:NOTICE: Failure to acknowledge: Solicitation No. DACW45 03 B 0011

Amendment No. 0002 14 April 2003

SUBJECT: Amendment No. 0002 to Specifications and Drawings for Construction of <a href="IDCC ROAD REHAB">IDCC ROAD REHAB</a>, BIG BEND - LAKE SHARPE, SD Solicitation No. DACW45 03 B 0011.

SECTION A - A

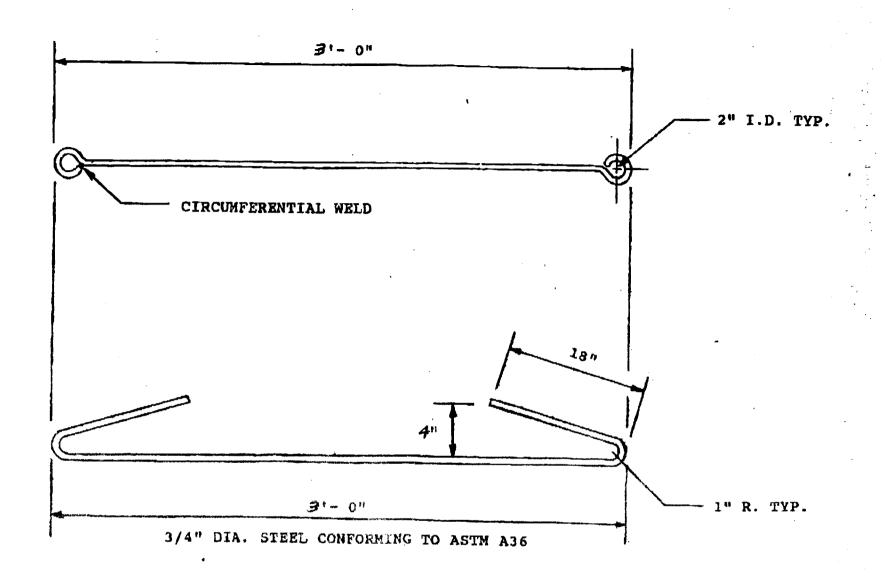
- a. Specifications. (Descriptive Changes.)
- (1) Page 00010-1, delete date and time of bid opening shown and substitute "22 Apr 2003" at "2:00 pm".
- (2) Section 02800, add the boat ramp planking details to the end of the Section PRECAST BOAT RAMP PLANKING. (See attachments at the end of this amendment).

DETAIL A1 A2

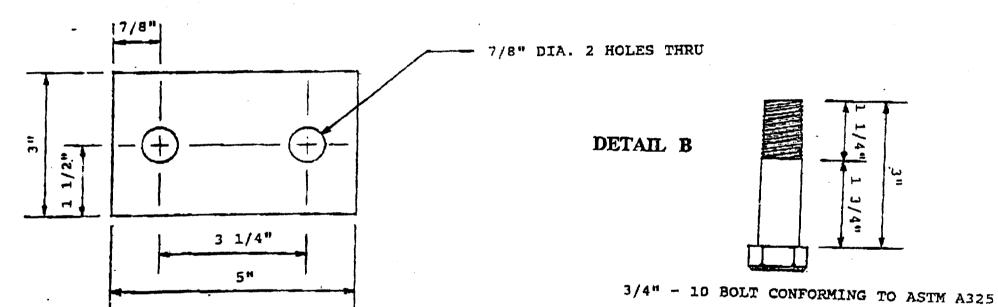
NOTE: // NUT AND WASHERS ARE TO BE

CONSISTENT WITH BOLT

2) BOLTS (2 ench) to be tack welded

2) BCLTS (2 ench) to be fack welded to the bottom place around bott head.

3/8" BAR x 3" x 5" CONFORMING TO ASTM A36 (2 each connection)
